**SERVICE BULLETIN**

EQUIPMENT SERIES: 62S

BULLETIN NO. 1

EQUIPMENT TYPE: 62S-1 VHF CONVERTER

Figure 1. Partial Bottom View of 62S-1

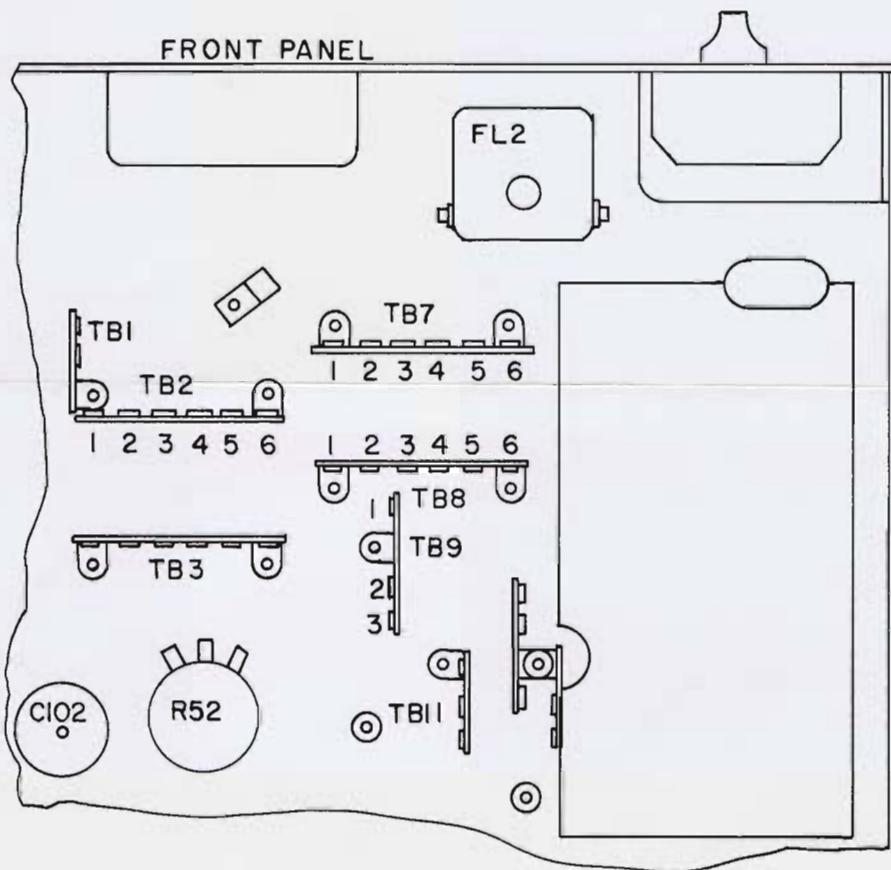
5. Place the unit upside down on the working surface with the panel closest to the operator. Refer to figure 1 for chassis layout and figure 2 for schematic diagram of modified circuit. (Reference also may be made to the 62S-1 Instruction Book, figure 6-2 for chassis layout.)

6. Locate terminal strips TB7, TB8, and TB9 above and slightly to the right of FL2. It is suggested in performing this modification, that all disconnecting and removal of components and wiring be done first, and then steps 7 through 16 gone over again to reconnect and install components and wires as specified. Grasp with a long-nosed pliers, or other suitable heat sink-device all diode leads to be connected or that are connected to terminals to which heat is applied.

7. Remove .1-uf disc ceramic capacitor C124, connected from TB7-2 to TB7-3.

8. Locate and remove the lead of 220-uhy choke L44, connected to TB8-3. Connect this lead to TB8-2
9. Locate and remove the lead of 1K, 1/2-watt resistor R21, connected to TB8-2. Connect this lead to TB9-1.

10. Locate and remove the leads of 18K, 1/2-watt resistor R59, connected from TB8-2 to TB9-1. Connect the leads of this resistor from TB8-3 to TB7-3.
11. Locate and remove the white-black-green wire from TB7-3. Connect this wire to T37-4.

12. Locate and remove the green wire from TB8-3. Connect this wire to TB8-2.
13. Locate and remove the white-black-red-green wire from TB8-2. Connect this wire to TB9-1.

14. Connect 47K, 1/4 watt resistor R75 (745-0809-00) from TB8-2 to TB9-1.
15. Connect 1N457 diode CR10 (353-0204-00) from TB7-2 to TB7-3 with cathode (color bar) end connected to TB7-2.

16. Connect other 1N457 diode CR11 (353-0204-00) from TB8-2 to TB9-1 with cathode (color bar) end connected to TB9-1.
17. All solder connections should be made carefully, and all loose wire clip-pings and solder removed.

Figure 2. Schematic Diagram of Changes Resulting from this Modification

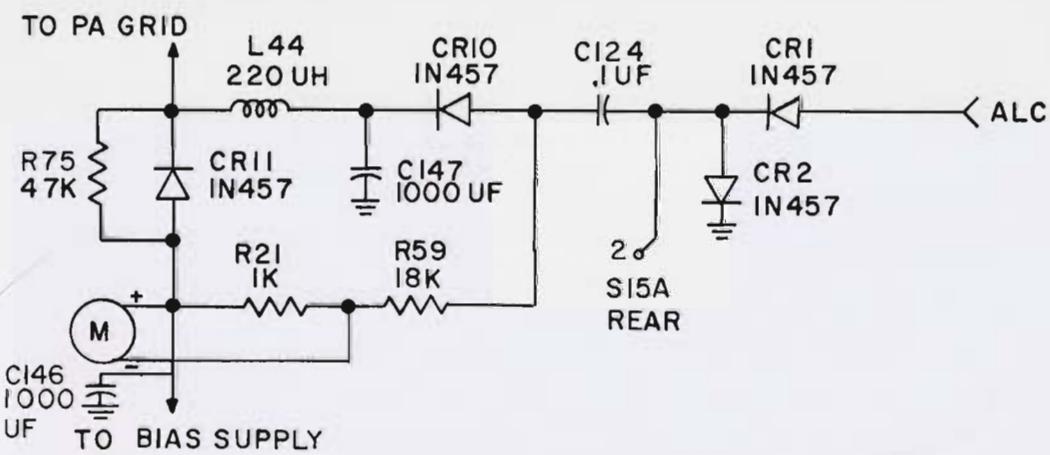
This modification will improve operation of the alc circuit. A 1N457 diode, CR10, is added to limit the operation of this circuit to changes in grid current of the proper polarity only. An additional 1N457 diode, CR11, and 47K resistor, R75, are added to increase efficiency of operation by providing a low impedance path between the PA grid and bias supply.
